RSN: 1137784
Permit #: 2016 1153805

City of Aurora Building Division
Reviewed for Code Compliance
Approved as Noted: *John Eckert*
Date: **Aug 15, 2016**
2015 INTERNATIONAL CODES & 2014 NEC

AURORA UROLOGY
1411 S. POTOMAC, SUITE 210

MECHANICAL FLOORPLAN

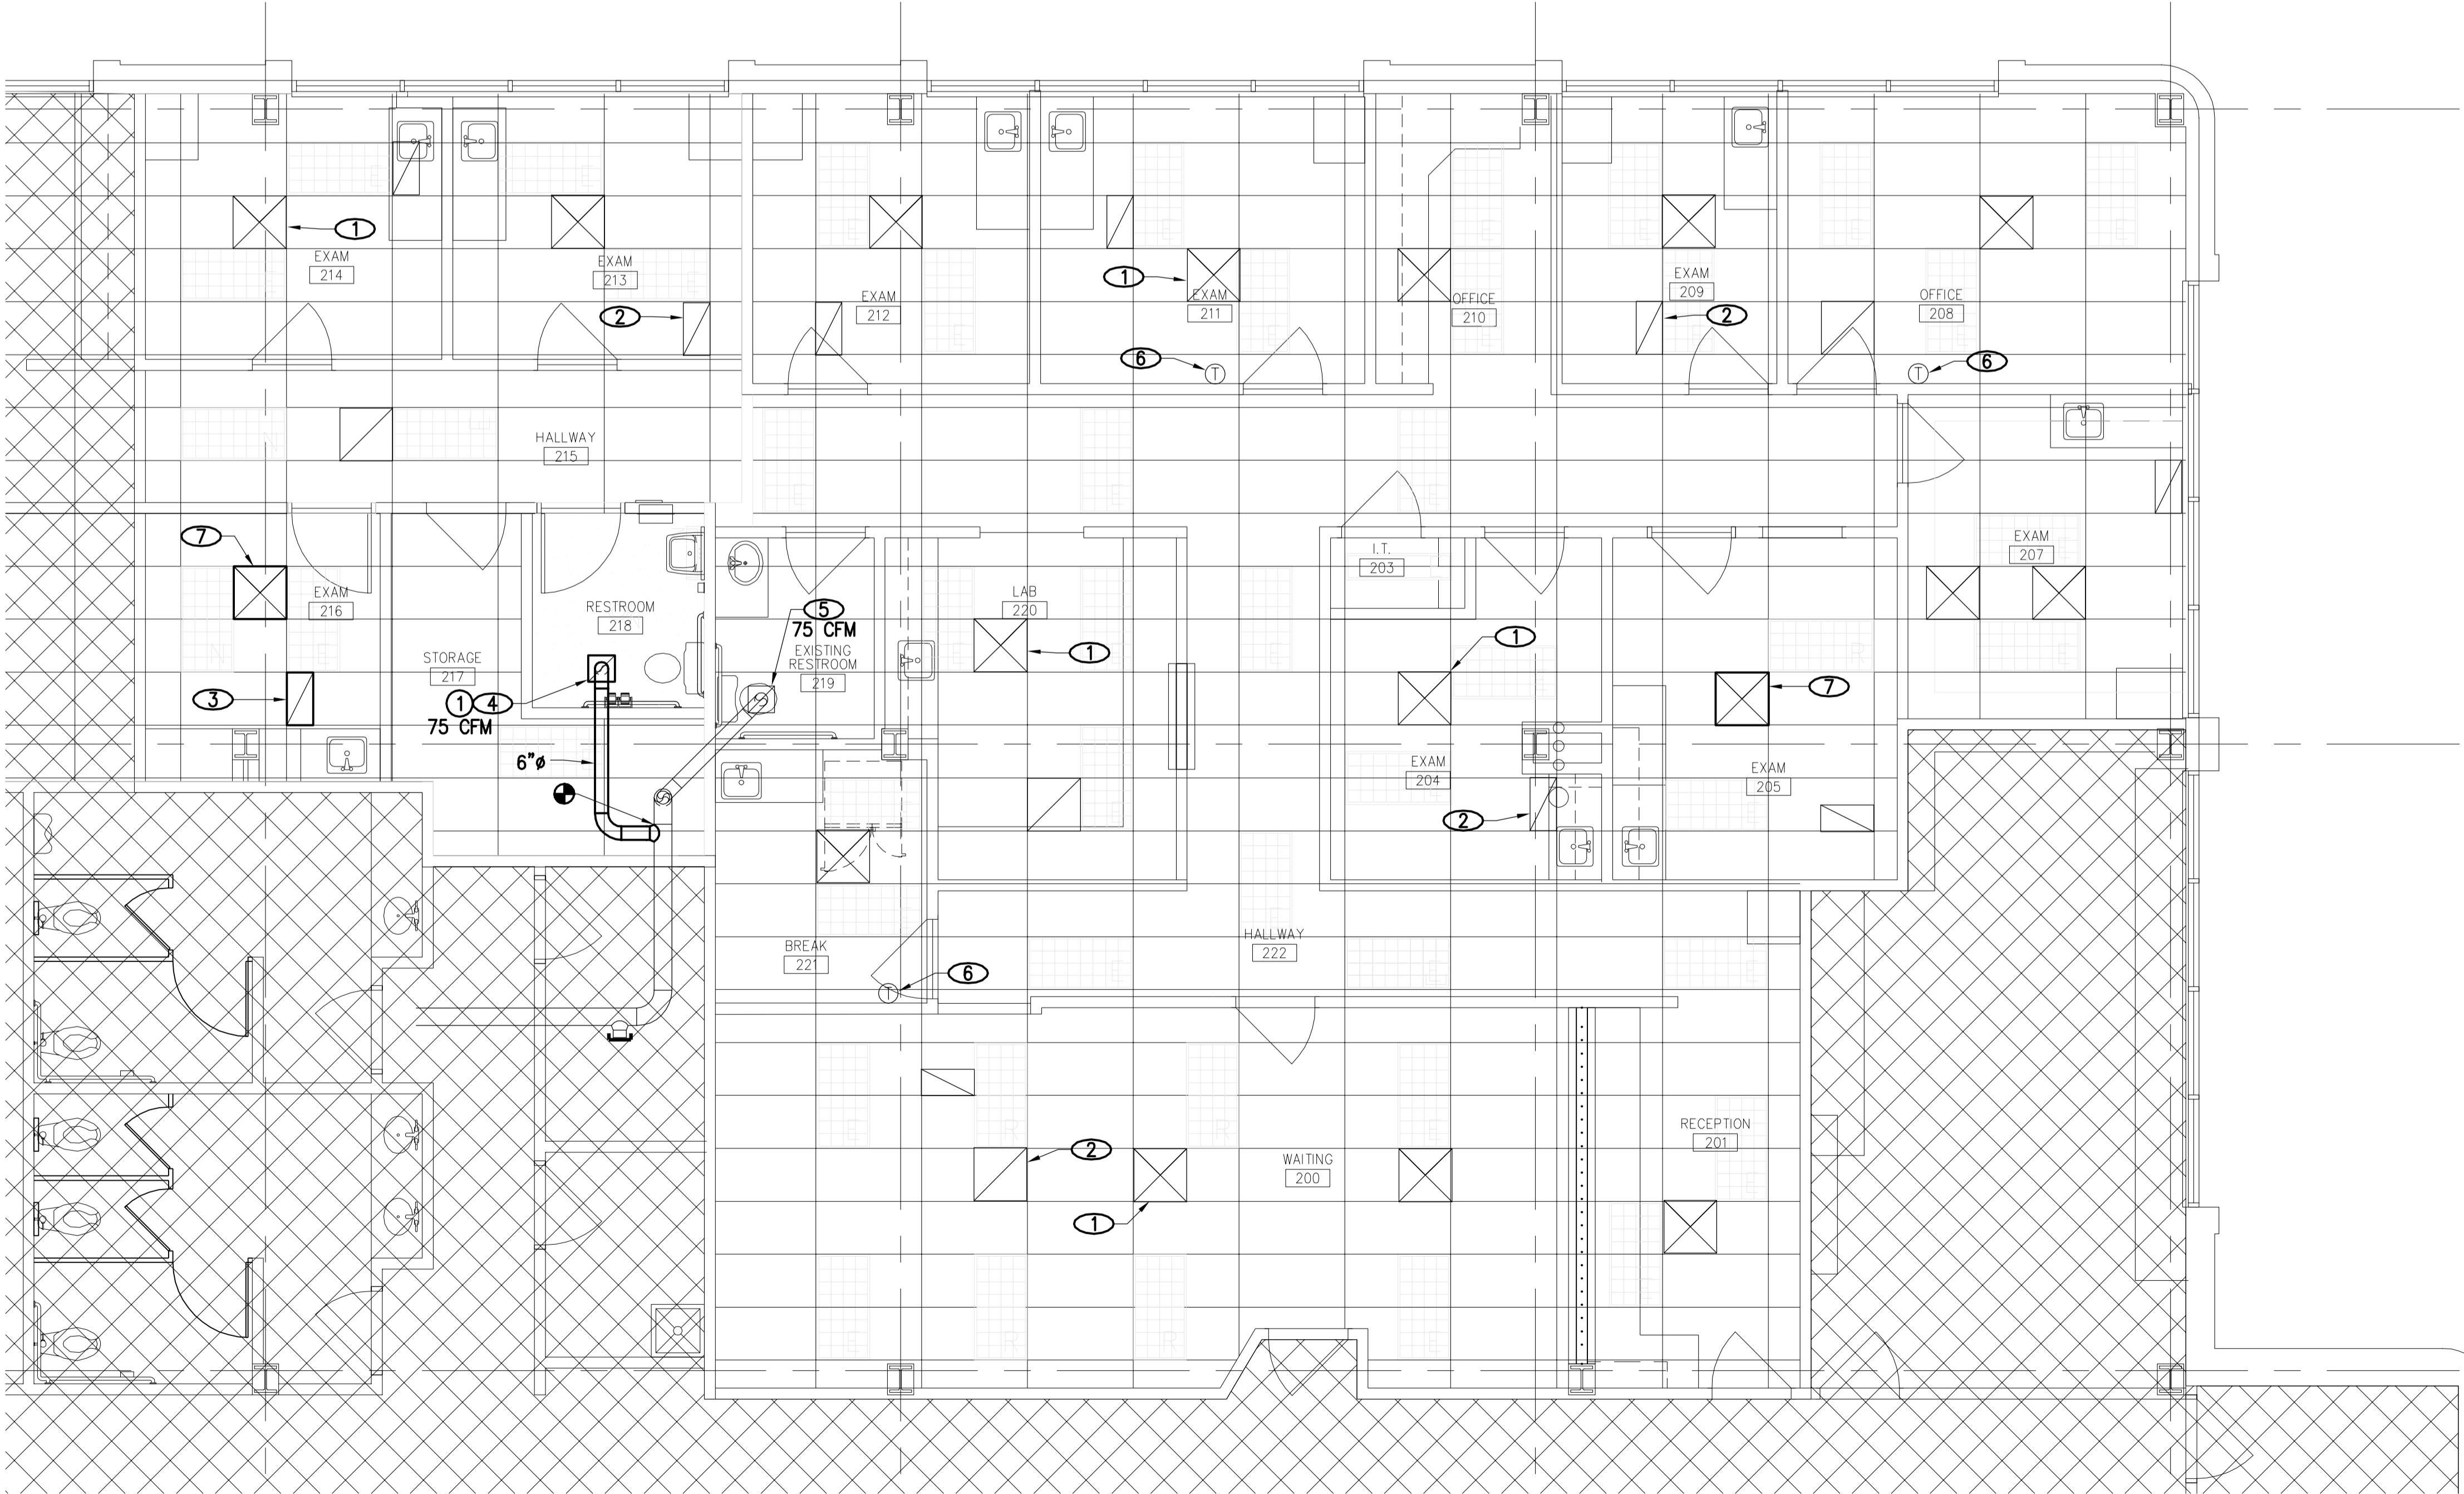
Provide proof of a flame spread less than 26 and a smoke development less than 50 for any material used in a plenum.
2015 IMC 602.2.1

Heating system shall be capable of maintaining 68 degrees F a 3'0" above the floor.
2015 IMC 309, IRC 303.9 and IBC 1204.1

PLUMBING FLOORPLAN
1/4"=1'-0"

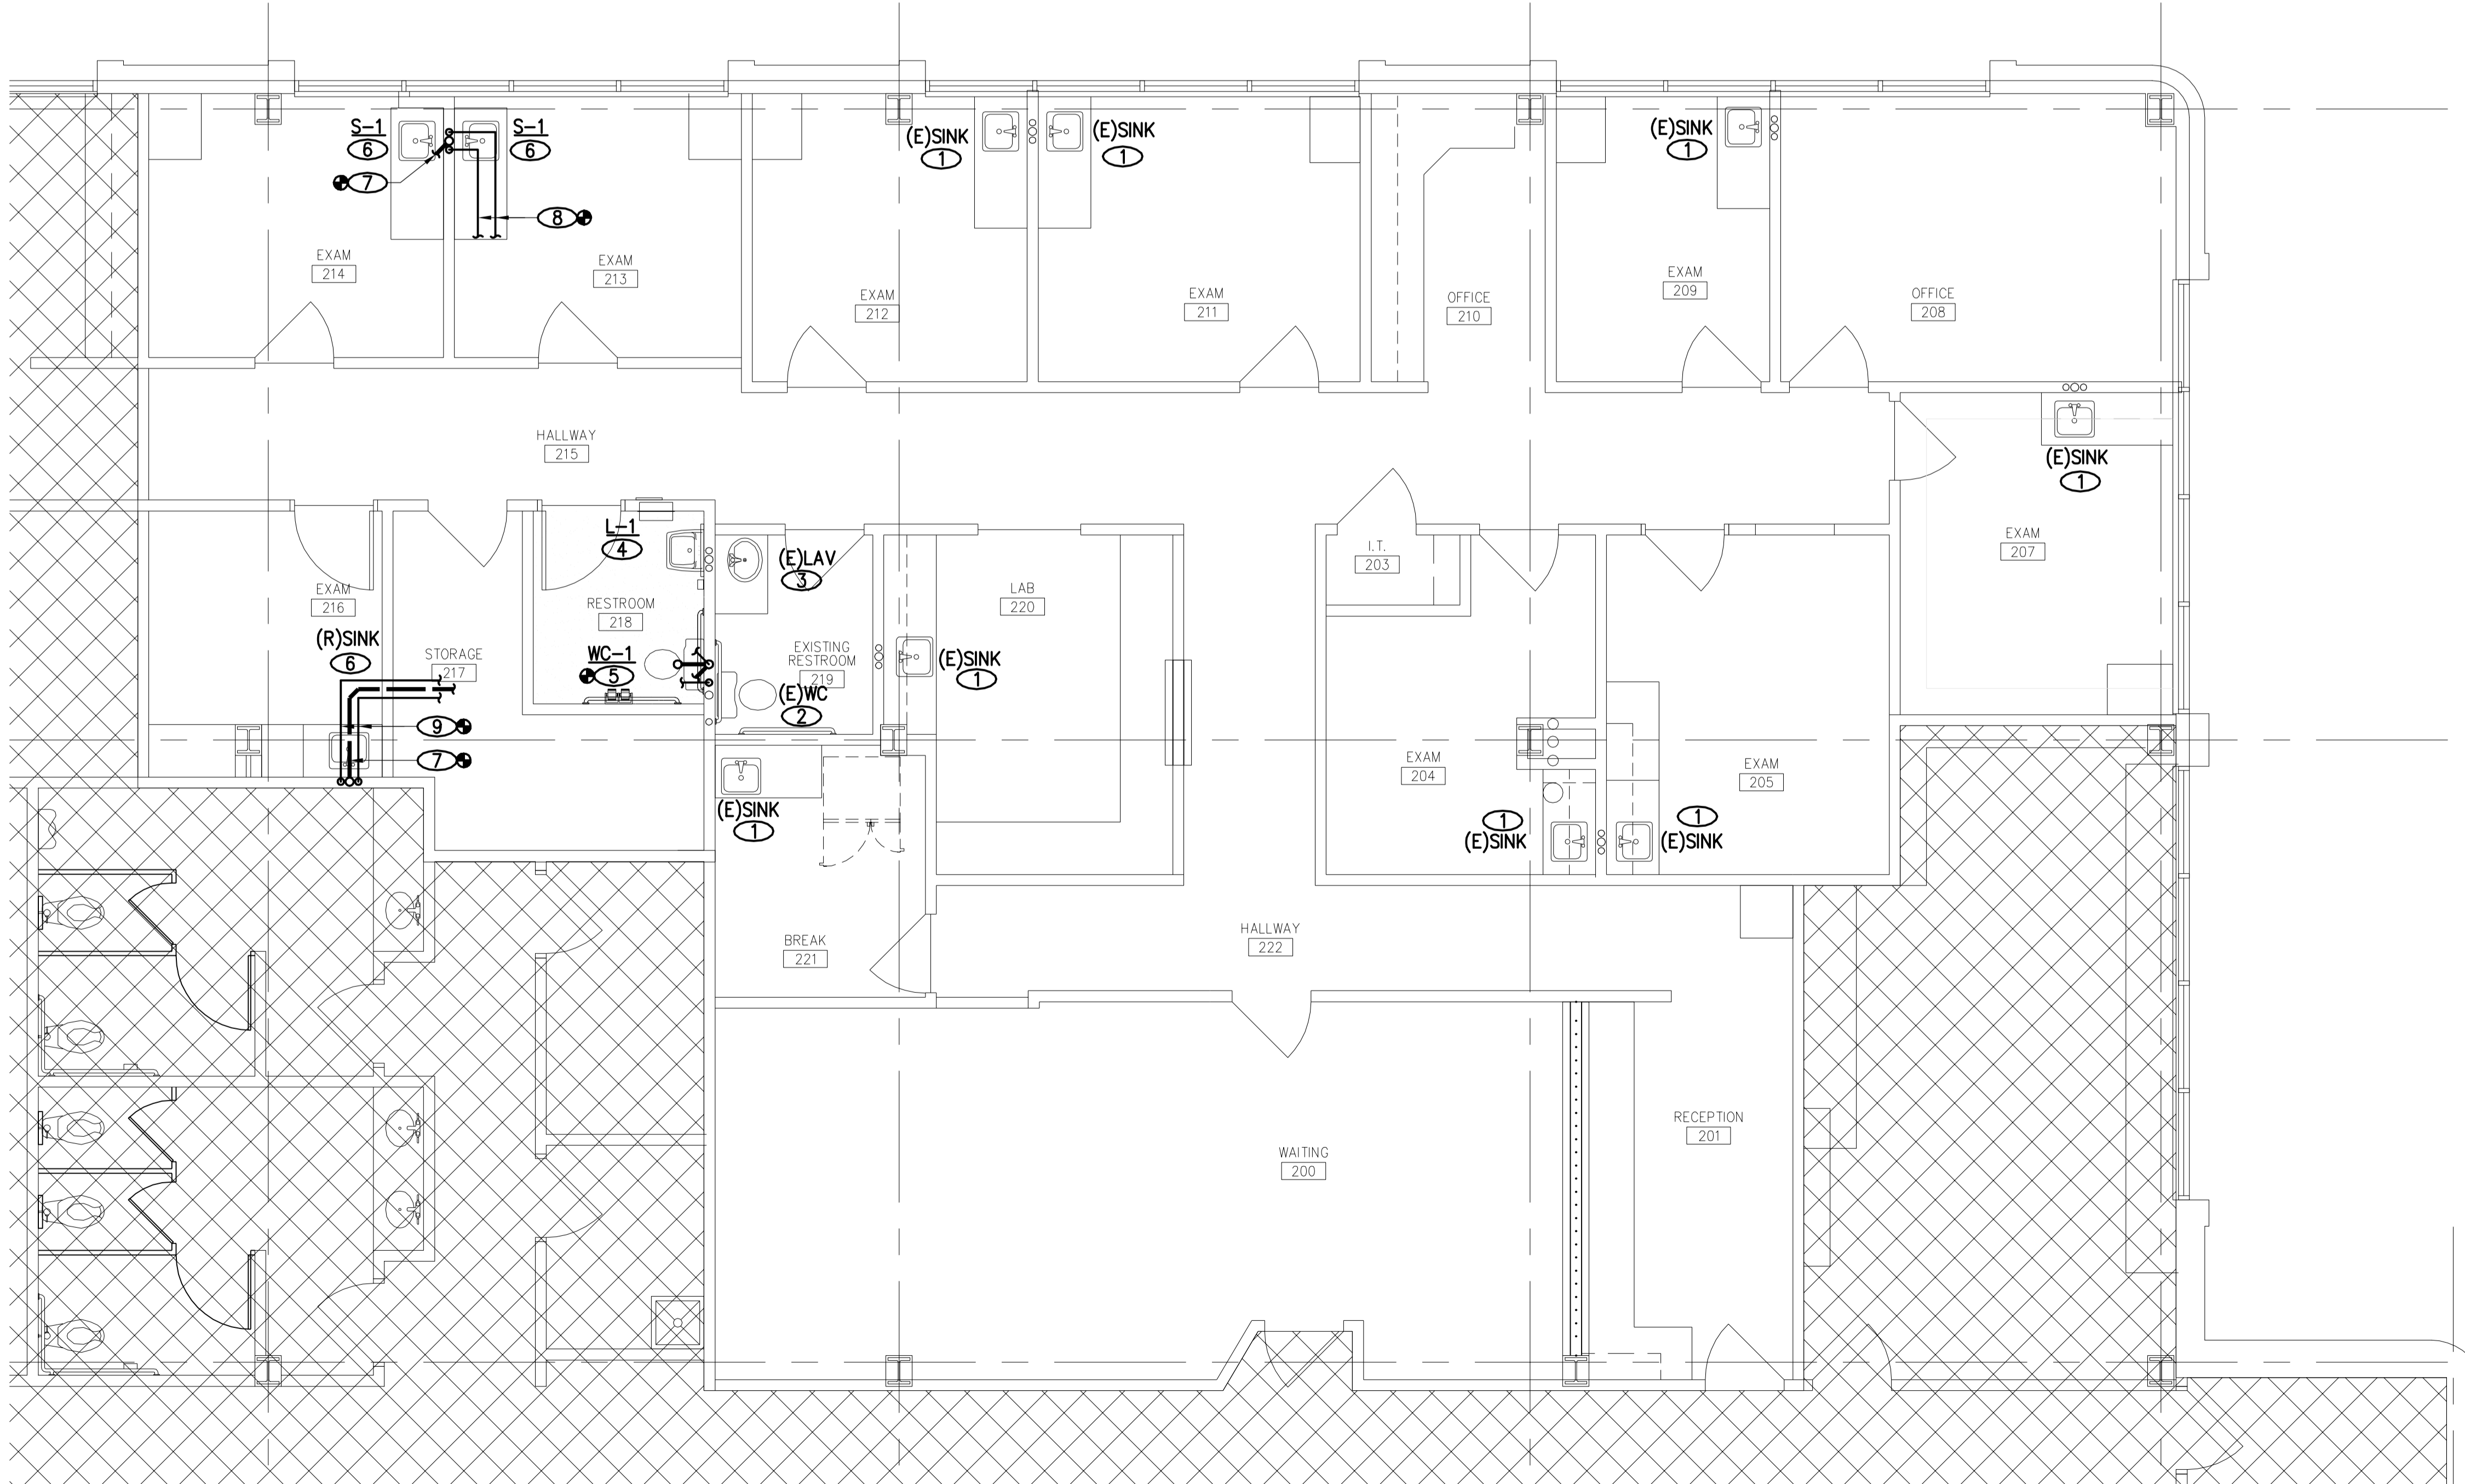
Provide self-closing or metered faucets in public restrooms.
2015 COA 22-326 (a)
